The **TRIUMPH** Service Sheets and other Technical Data Collection

Service 1 Contents List

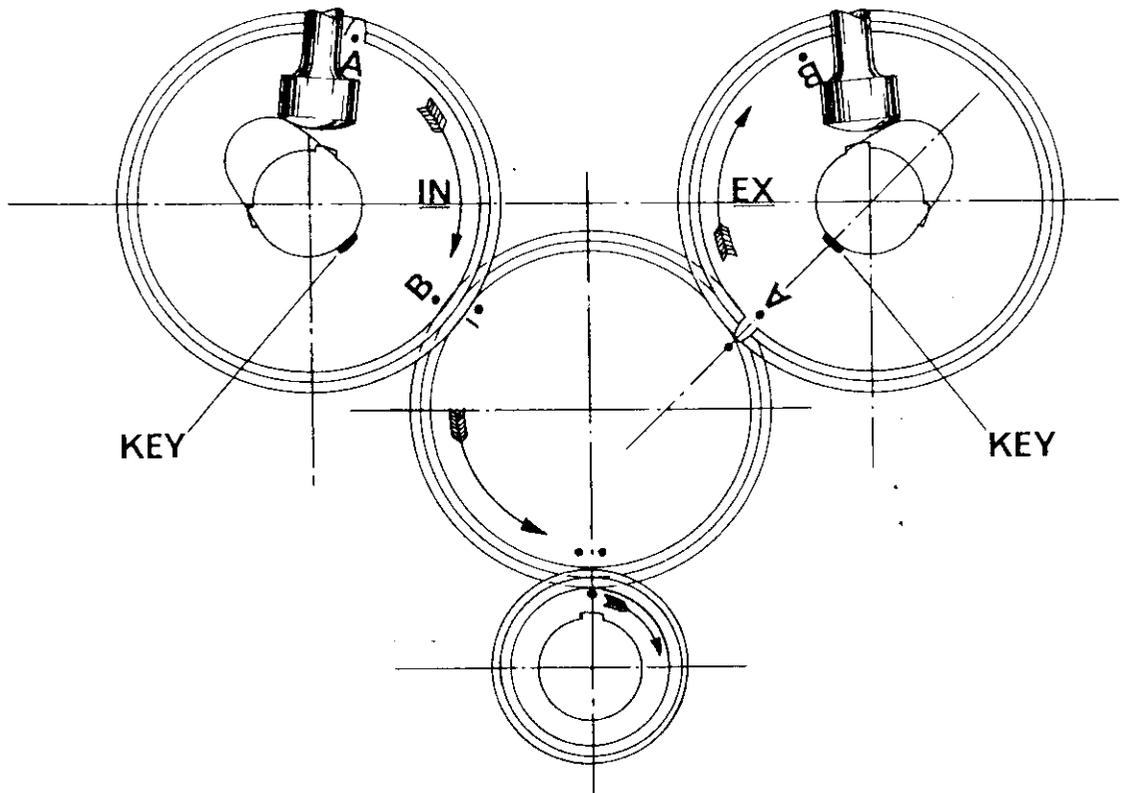
From engine number TR7RV 21257 these marks are ~~identical~~^{AS} with the accompanying ~~Passport~~^{Passport} "A" and "B" models built prior to this engine number are without such identification and to ensure that confusion does not arise when removing/replacing the gears from their respective camshafts, reference should be made to the valve timing diagram below.

Note the position of the timing marks relative to the keyway in use.

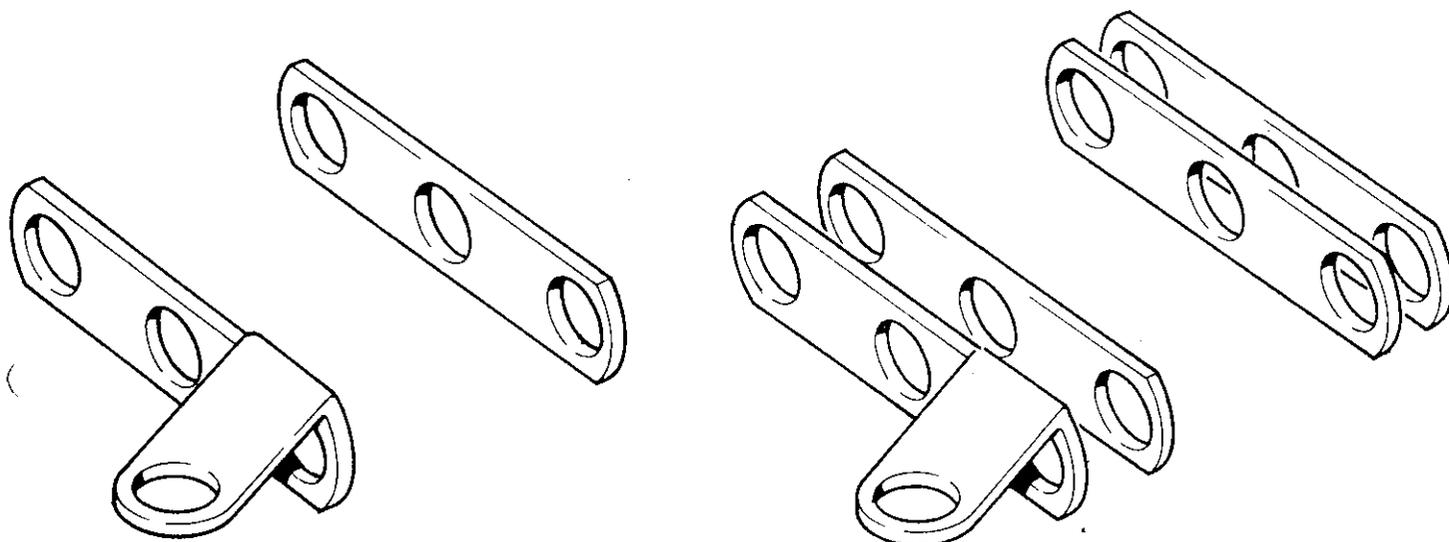
After engine no. NH.17668 a modification was introduced whereby 2 off 97-4446 bracket is fitted to the right hand fork leg and 1 off 97-4477 and 1 off 97-4446 brackets are fitted to the left hand fork leg.

Bracket assemblies are shown in the diagrams below : .

Later Models

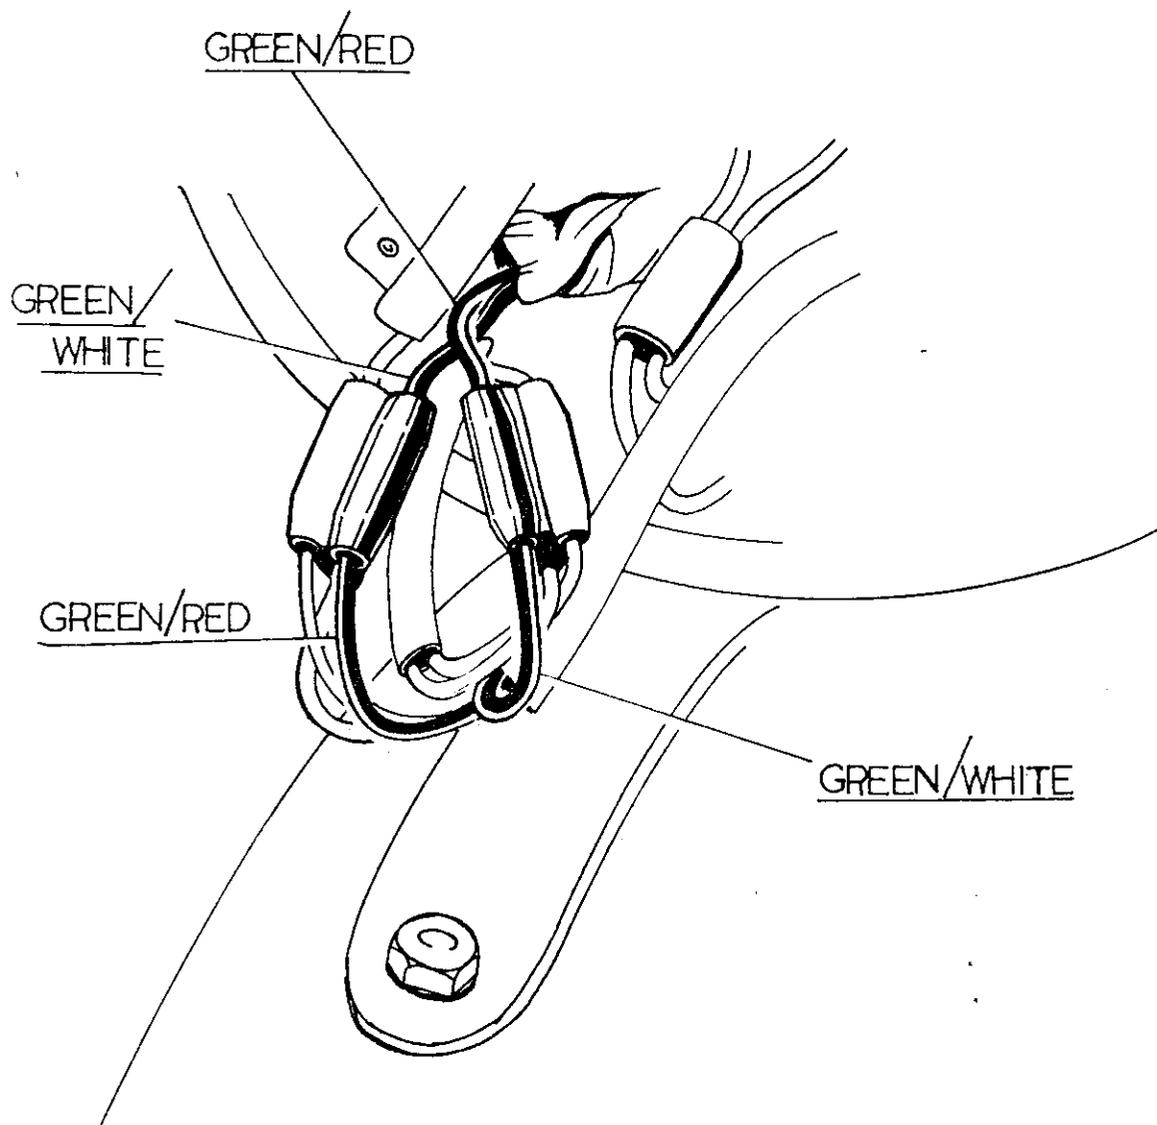
1. The R.H. front/rear turn signal is now fed by the green/red wire.
2. The L.H. front/rear turn signal is now fed by the green/white wire.
3. The green/white wire from the turn signal switch on the L.H. handlebar now feeds into the green/red wire at the snap connector in the headlamp.
4. The green/red wire from the turn signal switch on the L.H. handlebar now feeds into the green/white wire at the snap connector in the headlamp.
